**AMENDMENT – 3**

RFP No: **CANW-1/IWAI/JMV/16**

**Assignment Title: Engineering Procurement and construction contract for New Navigational Lock at Farakka, West Bengal**

This amendment forms an integral part of the Bid Document issued on 27<sup>th</sup> May, 2016.

JOB. NO. I-525 DRG. NO. FL-005 (SH: 2 OF 2)

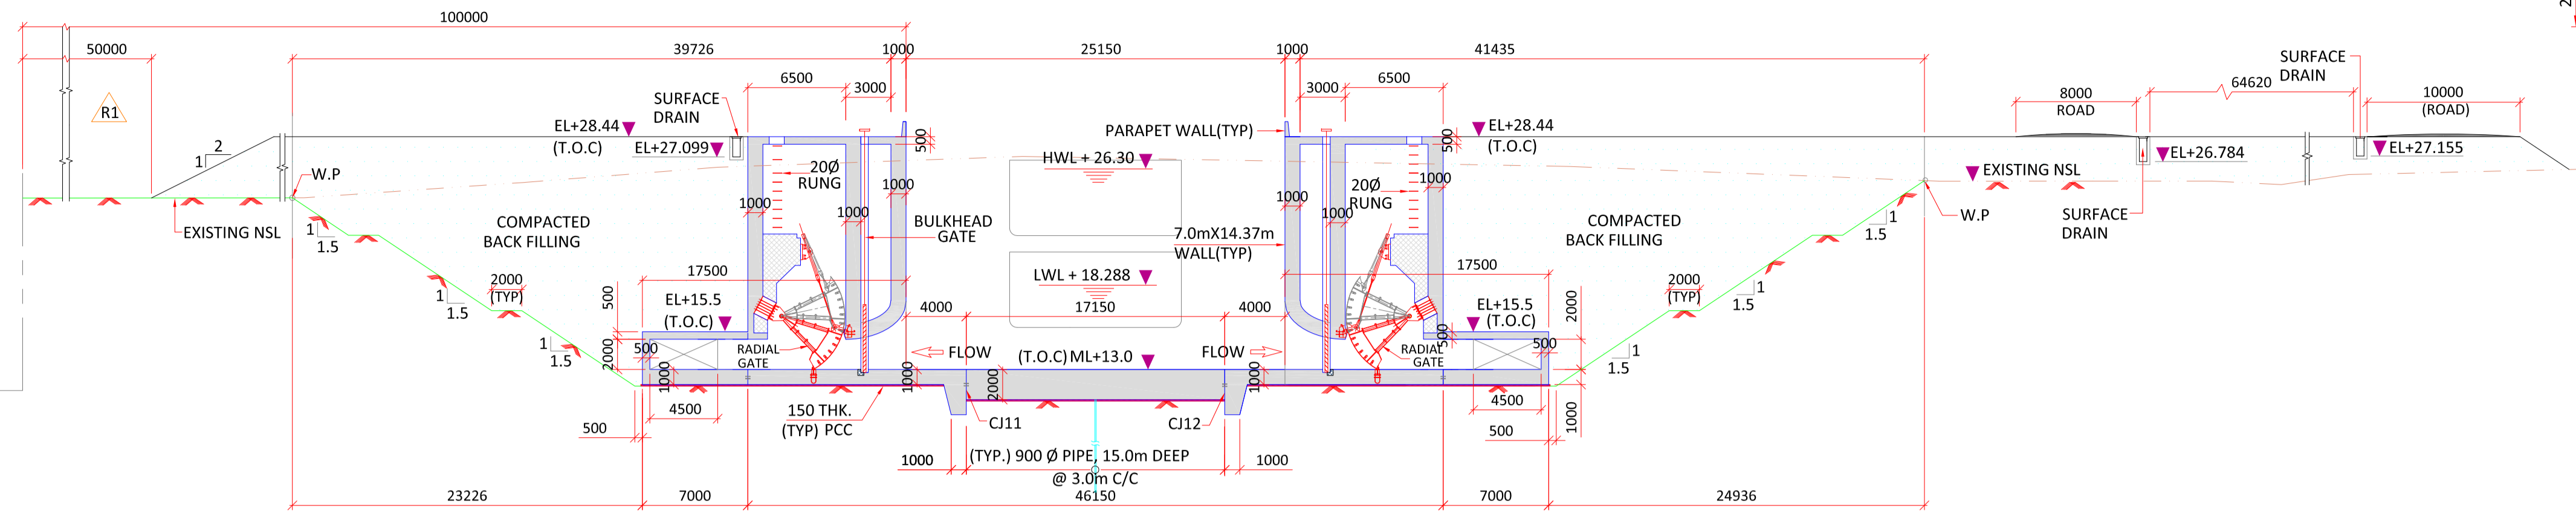
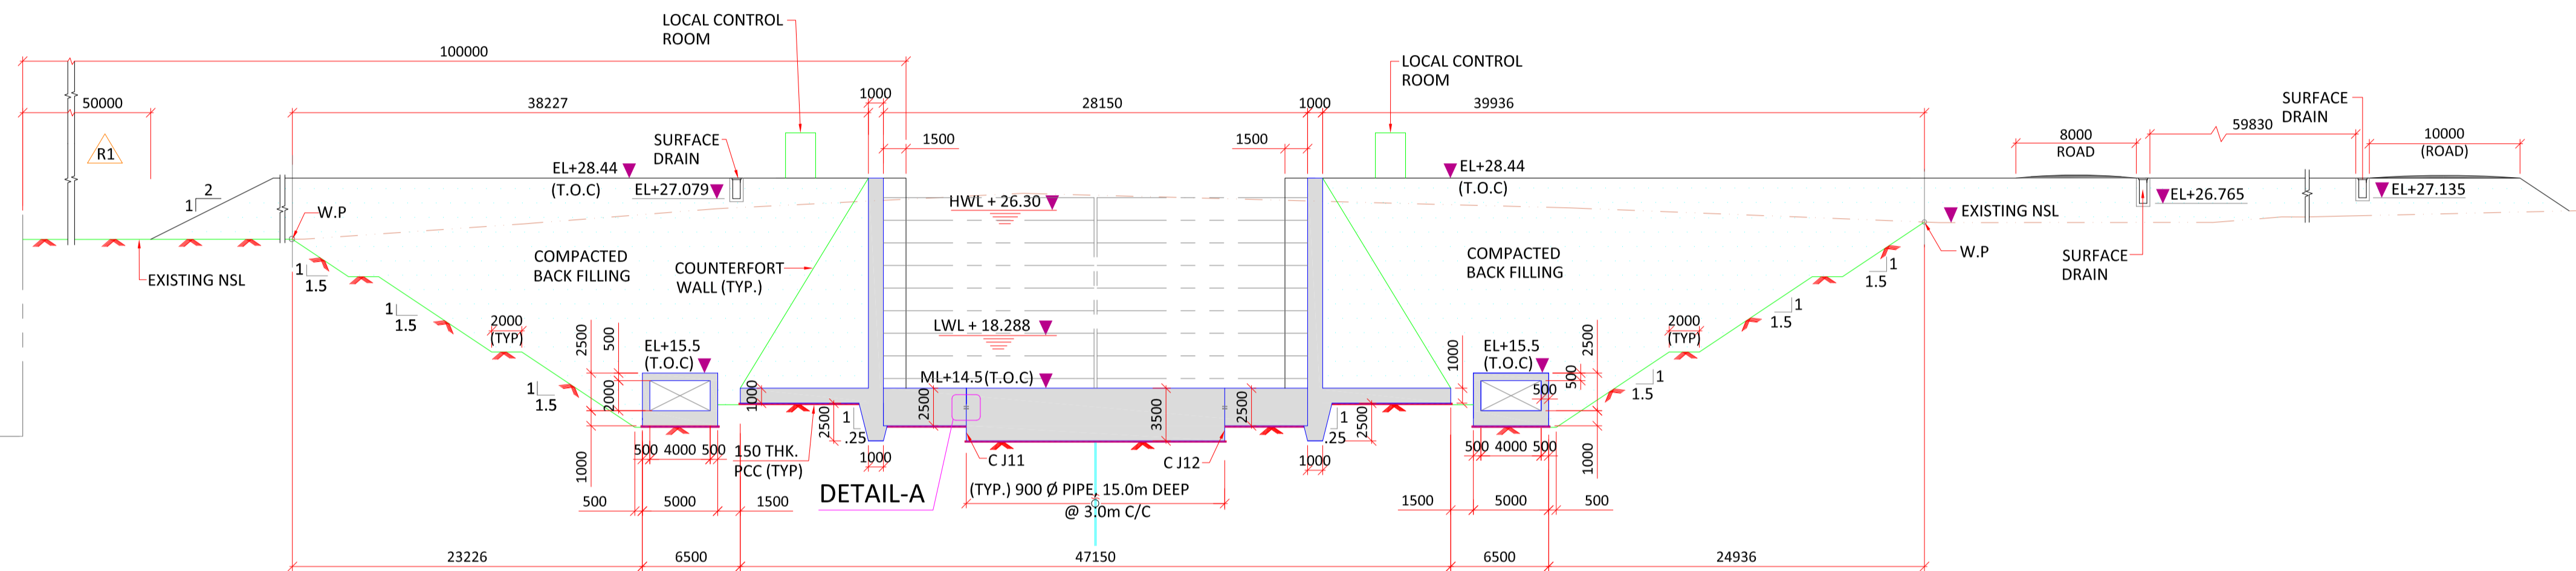
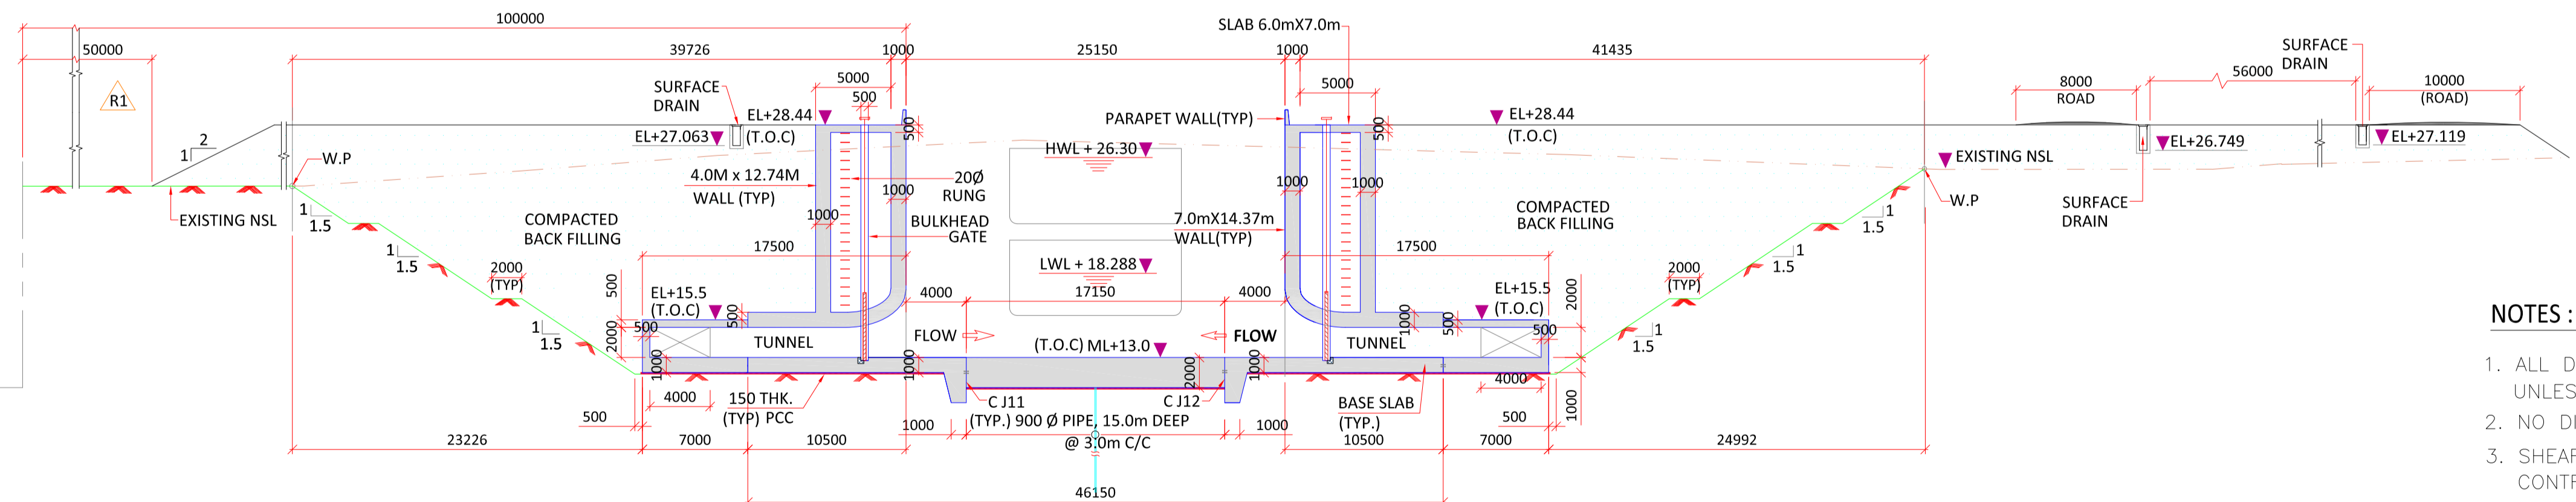
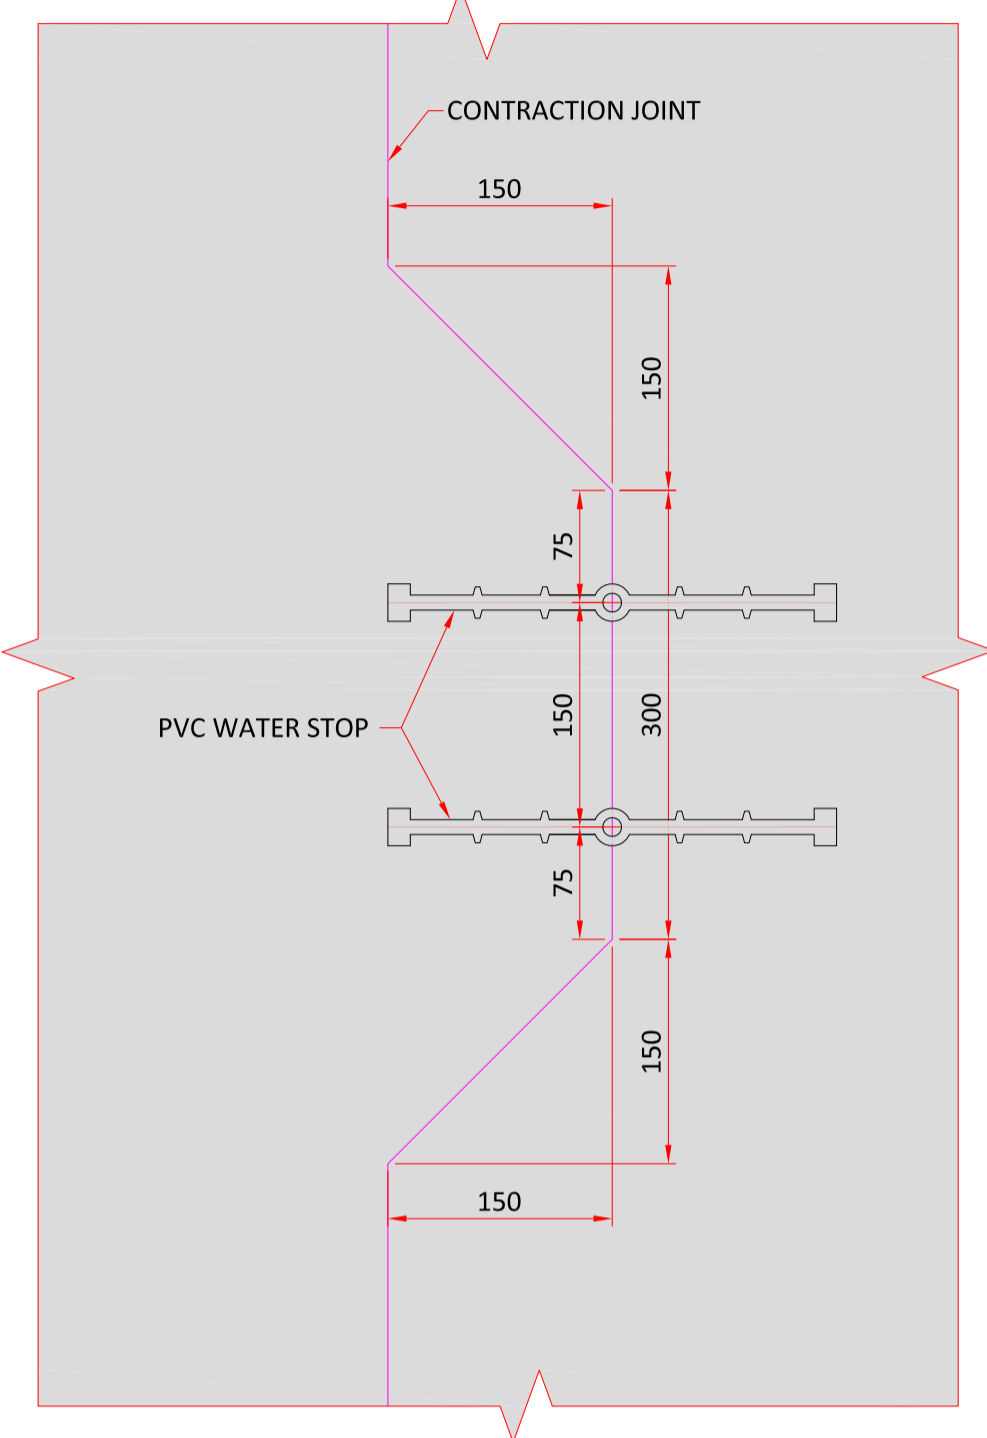
REV	DATE	DESCRIPTION	DRN	CHD	APD
R1	27.07.16	MODIFICATION IN FORMATION LEVELS	KS	SKA	SD

19.	Volume -3, Bill of Quantities		Utility Culverts Drawing no.FL-004 & FI-005	Section J-J in dwg FI-004 shows the clear height of the utility culvert as 2.0m where as in dwg. FL-005 the clear height is mentioned as 2.5m in Section D-D	The utility culvert shall be 2m(w) x 3.5m(h). The drawing FL-005 amendment is attached.

JOB. NO. **I-525** | DRG. NO. **FL-014**

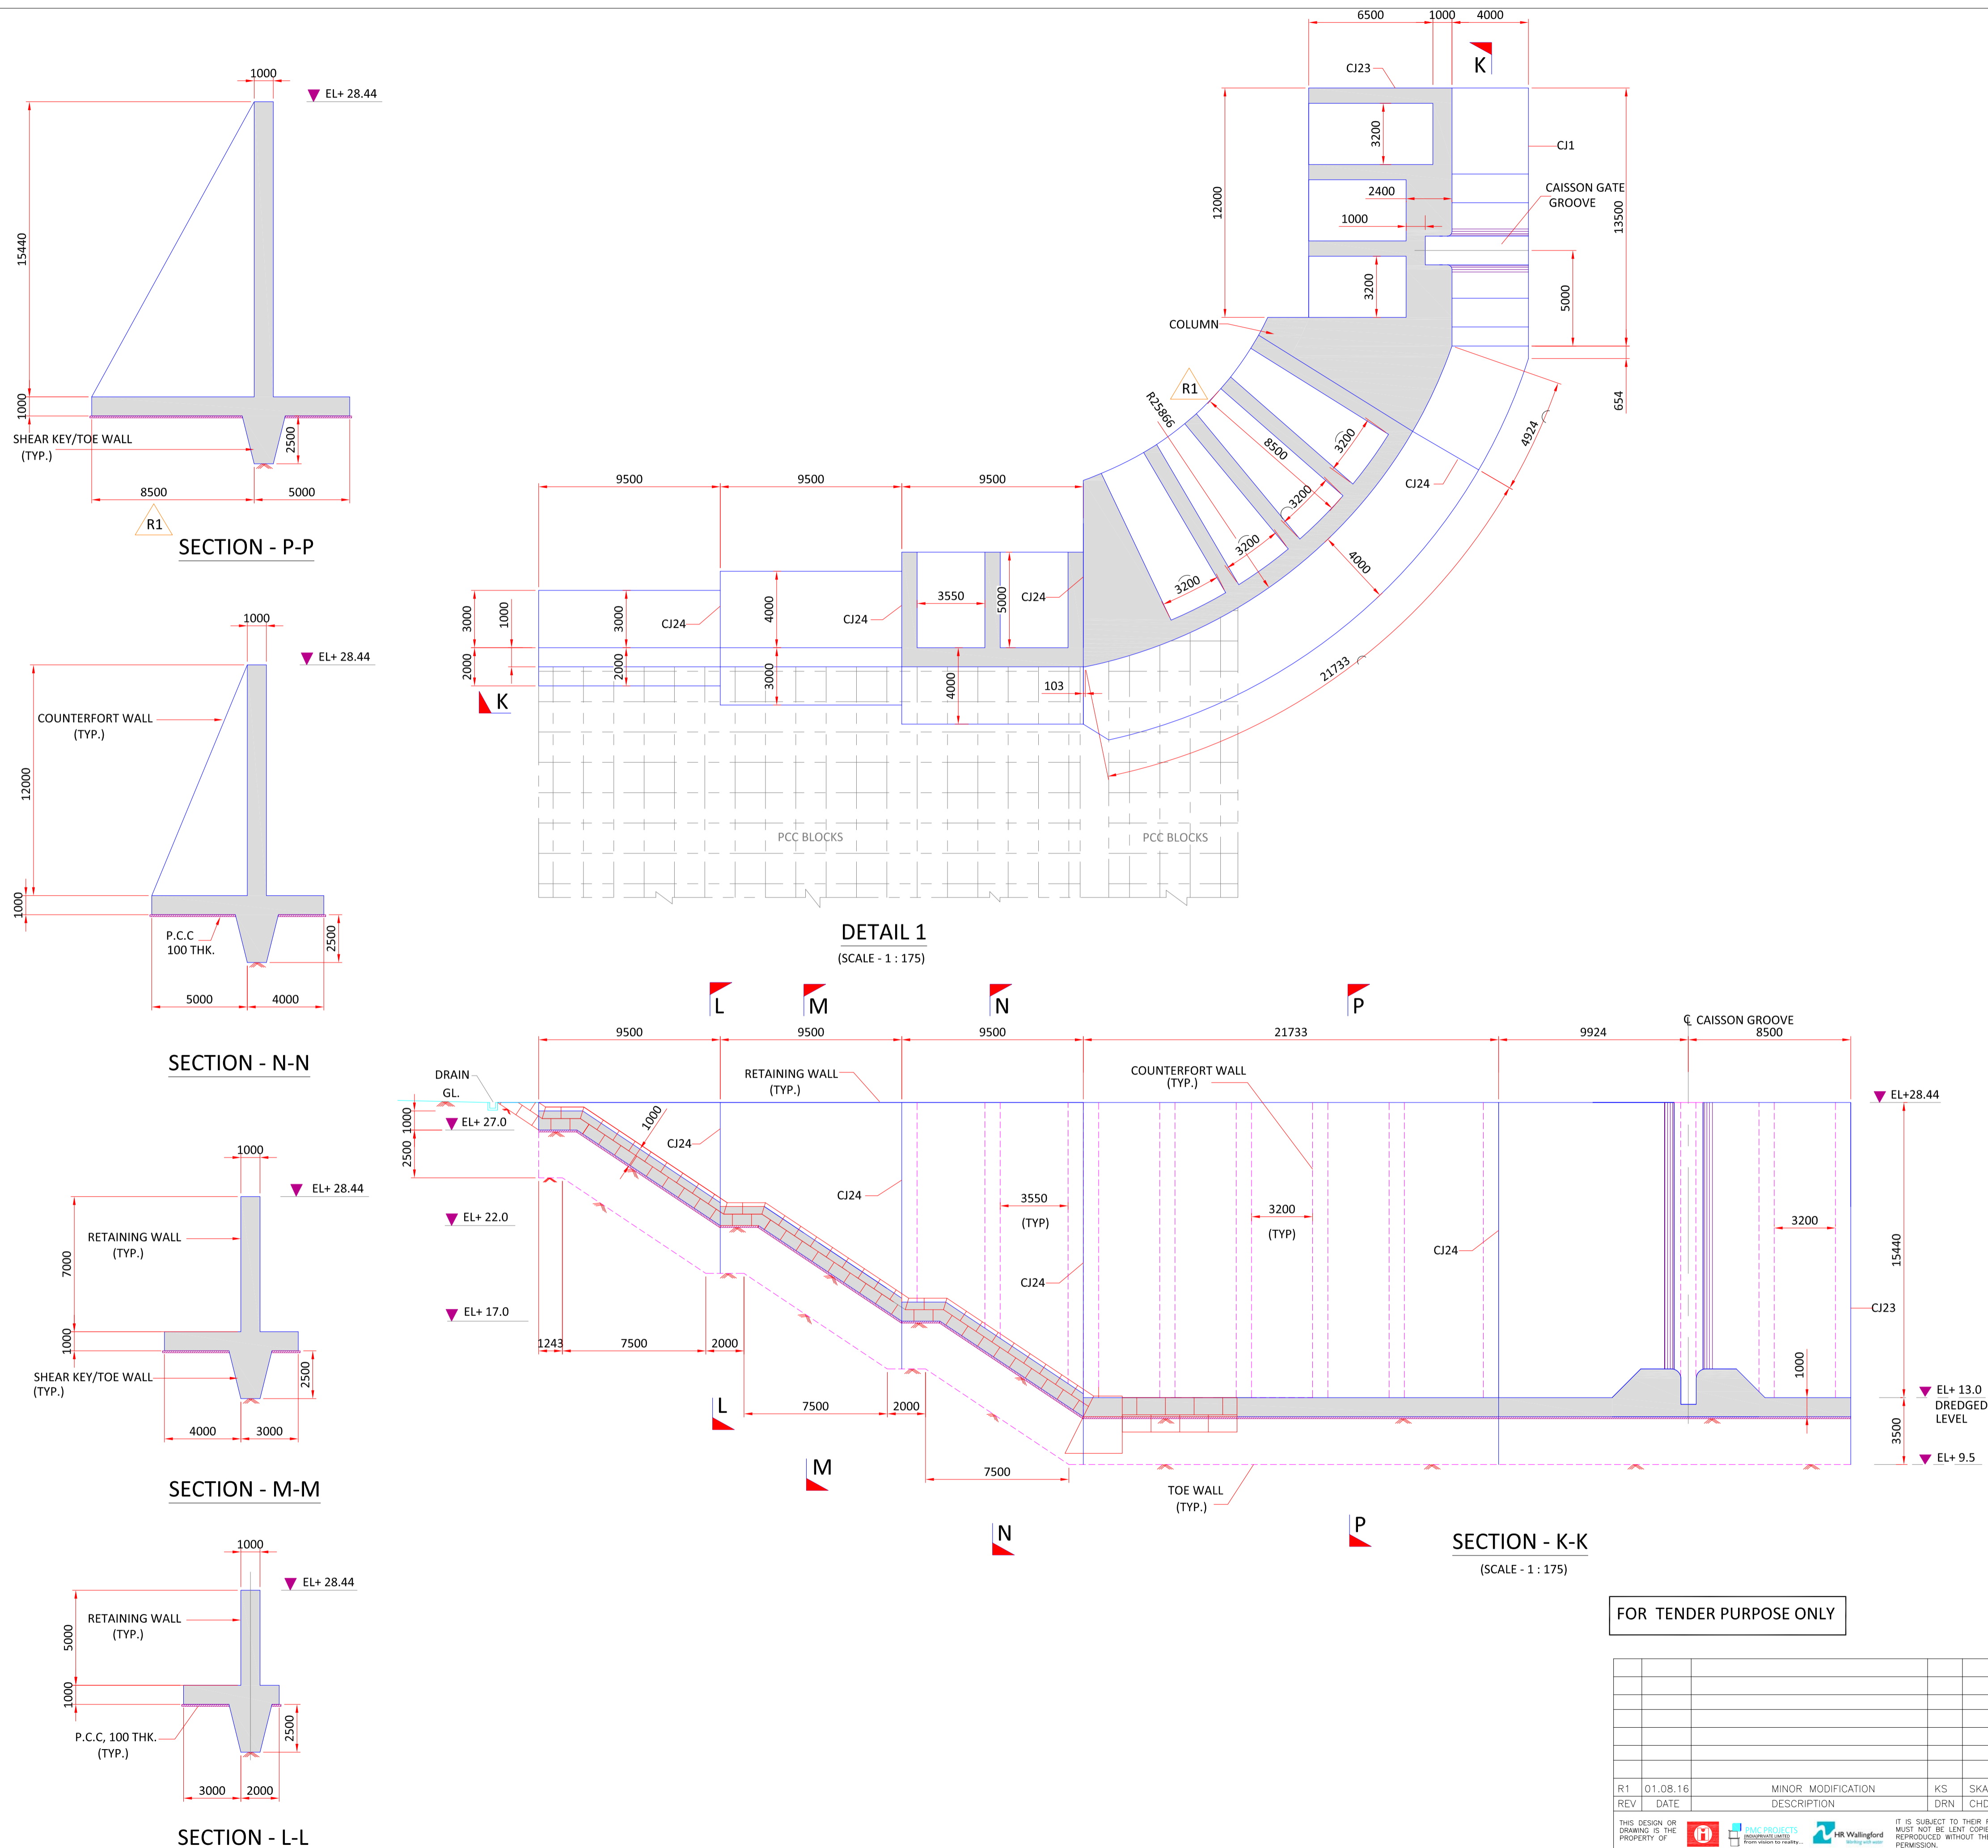
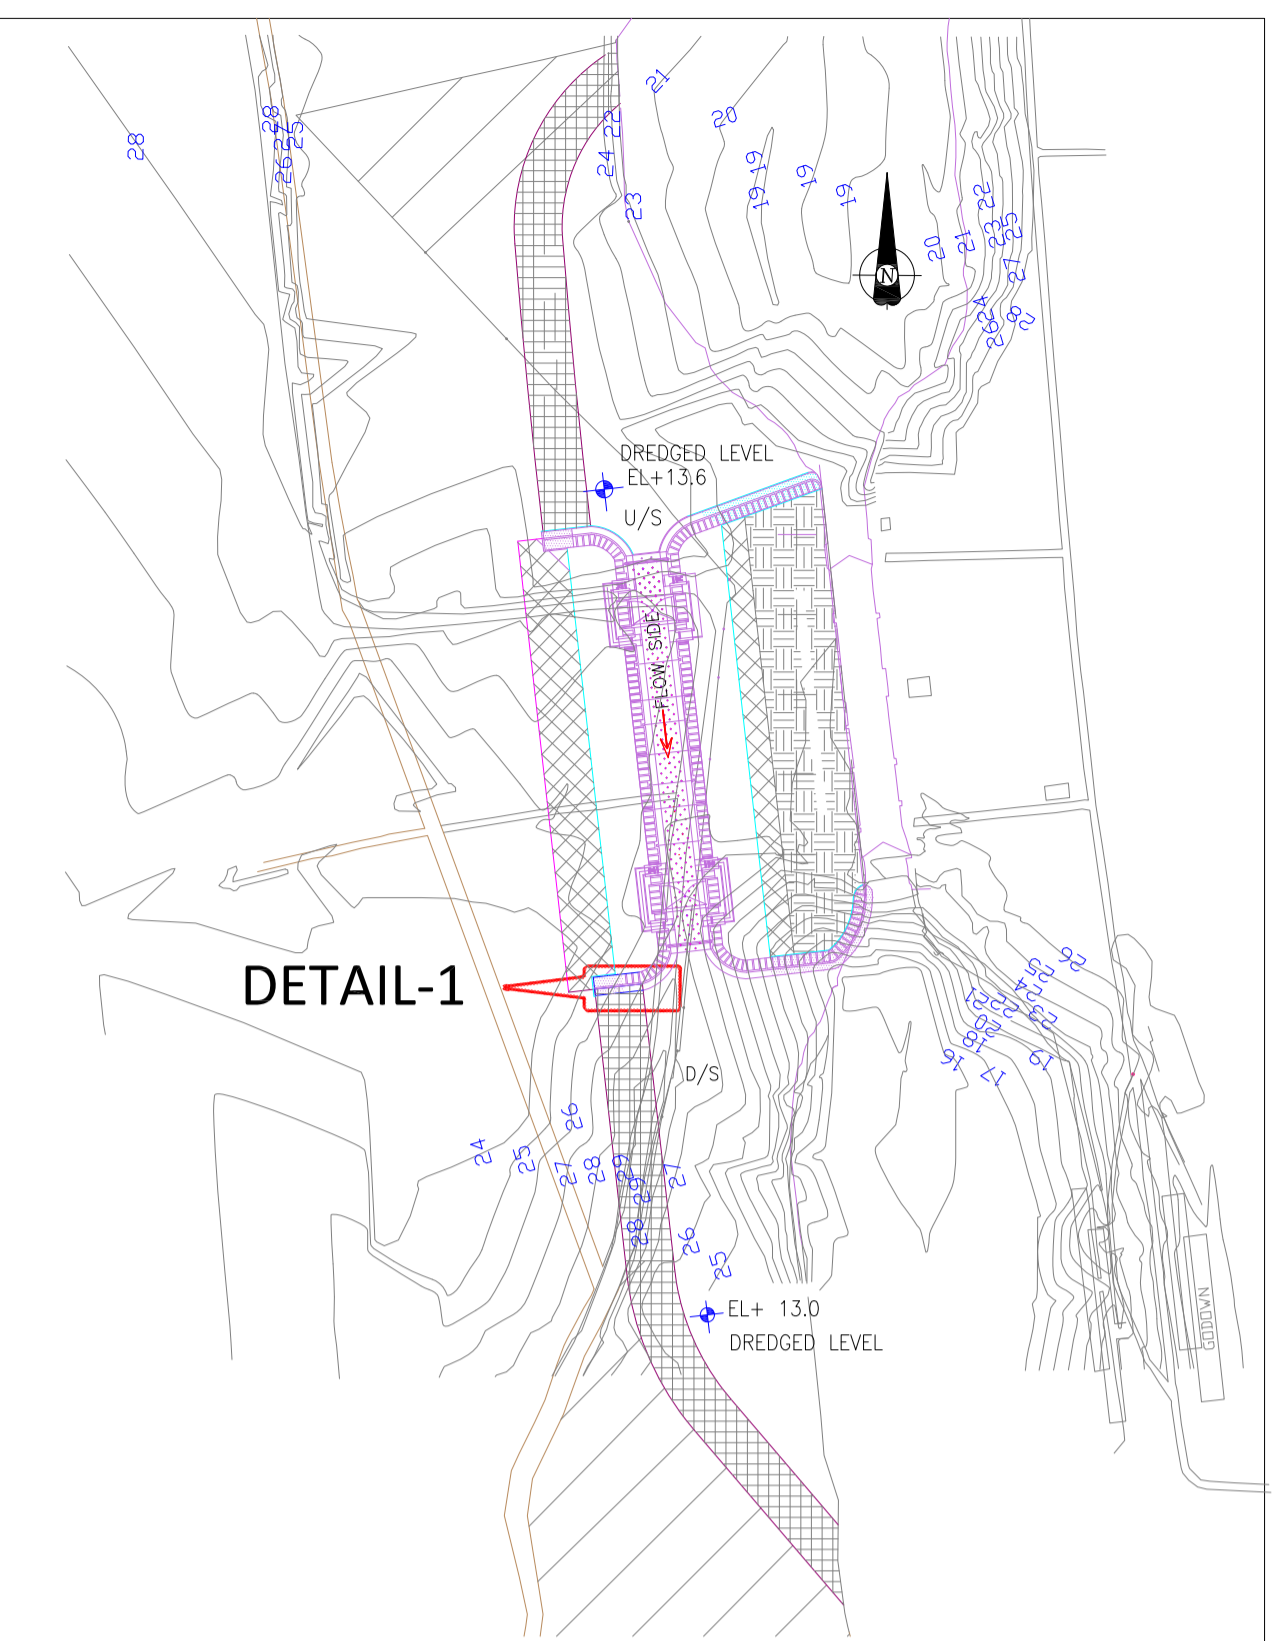
<b>S. No</b>	<b>Vol., Section &amp; Clause No. in Bid Document</b>	<b>Original Text</b>	<b>Replace with</b>
			venue as mutually agreed (for foreign bidder)
12.	Volume-2	FI-004	Revised drawing is enclosed
13.	Volume-2	FI-005	Revised drawings are enclosed (SH 1 and 2)
14.	Volume-2	FI-014	Revised drawing is enclosed
15.	Volume-2	FI-015	Revised drawing is enclosed

REV	DATE	DESCRIPTION	DRN	SKA	SD	APD
R1	01.08.16	MINOR MODIFICATION	KS	SKA	SD
